To: The Planning Board  
From: John P. Hansen Jr., AICP, Town Planner  
Date: July 2, 2013

**DEFINITIVE PLAN REVIEW**  
**Country Brook Estates – Plat 15, Lot(s) 302 (882 Arcade Ave.)**

This letter is being transmitted to outline our review of the revised Application submittals for the March 2013 Notice of Intent Application and Definitive Subdivision Plan Application submitted to the Town of Seekonk Conservation Commission (the "Commission") and Town of Seekonk Planning Board (the "Board"), respectively, for the Country Brook Estates project. Application submittals were revised in response to comments and recommendations provided in our original review letter dated May 2, 2013. Woodard & Curran has completed a technical and regulatory review of the proposed Country Brook Estates Subdivision project revised submittals for compliance with general engineering practice and the following:

**GRADING PLAN**

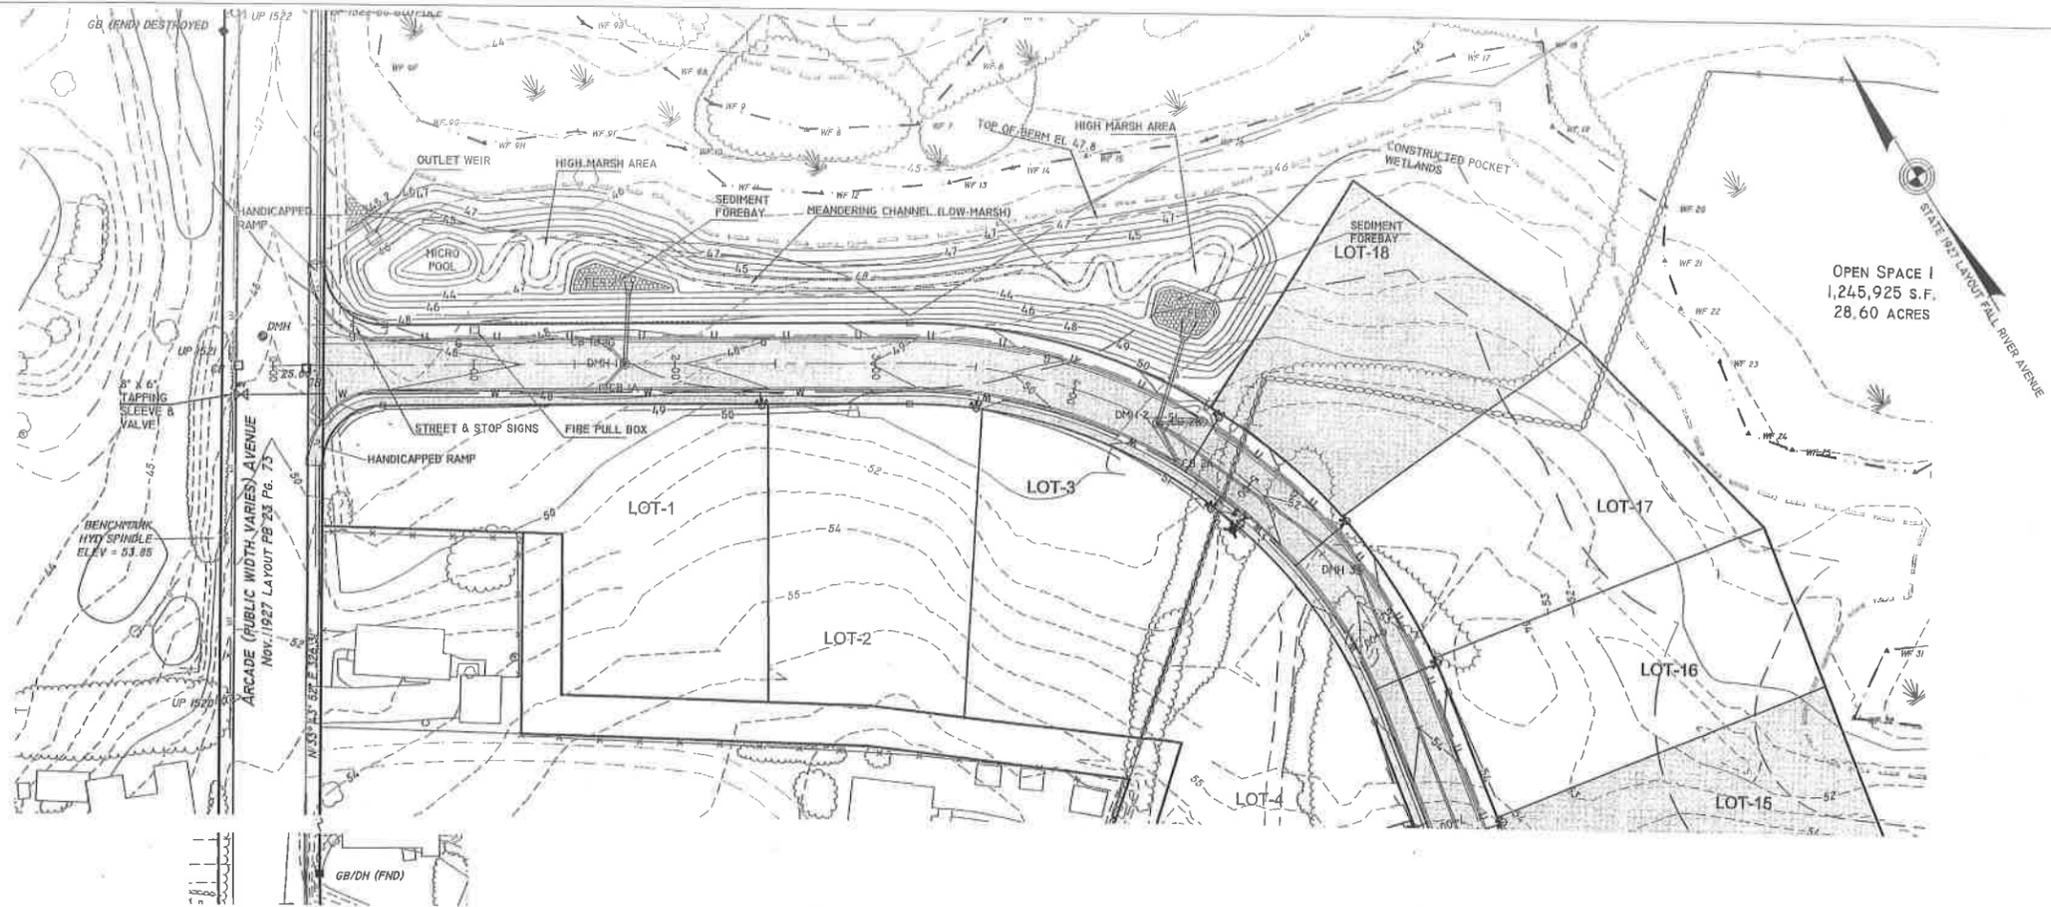
59. The Grading Plan does not depict an elevation 49 contour crossing the proposed road, as provided on the road profile. **The Applicant should revise the Grading Plan.**
